Monitoring Report- Year 6  
FINAL VERSION  
Pen Dell Mitigation Project  
Calendar Year of Data Collection: 2023

NCDEQ DMS Project Identification # 97079  
NCDEQ DMS Contract # 6824  
Neuse River Basin (Cataloging Unit 03020201)  
USACE Action ID Number: SAW-2016-00885  
NCDEQ DWR Project # 2016-0403 V2  
Johnston County, NC  
Contracted Under RFP # 16-006477  
Data Collection Period: March and October  
2023 Submission Date: December 29, 2023

**RE: WLS Responses to NCDEQ DMS Review Comments for Task 12 Draft Monitoring Report Year 6 for the Pen Dell Mitigation Project, NCDEQ DMS Full-Delivery Project ID #97079, Contract #006824, Neuse River Basin, Cataloging Unit 03020201, Johnston County, NC**

**Figure 4: Monthly Rainfall Data**  
**Pen Dell Mitigation Project (NCDEQ DMS Project ID# 97079)**  
**MY6 2023**

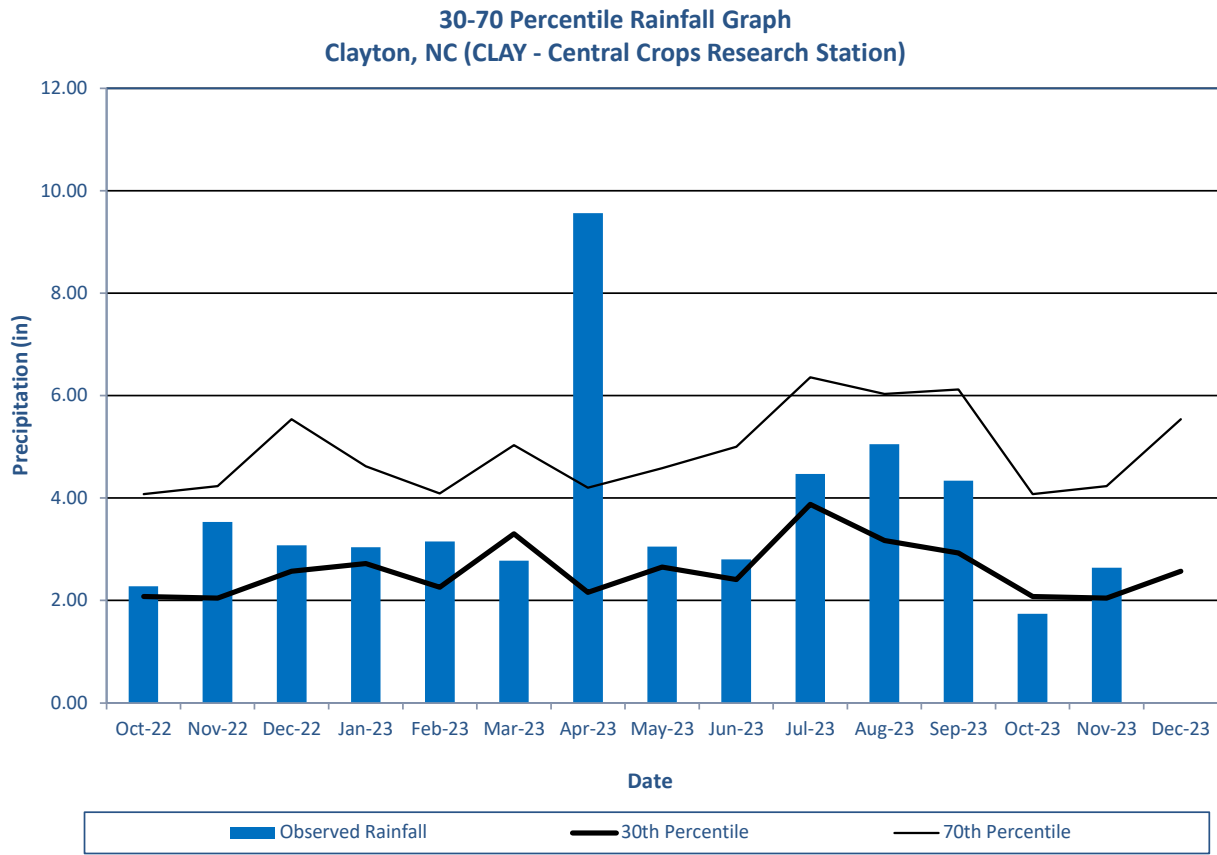
- 3. Appendix D, Figure 4: Please update with rainfall through November if possible.** WLS Response: Rainfall through November 2023 has been updated in the Appendix D Rainfall Table.
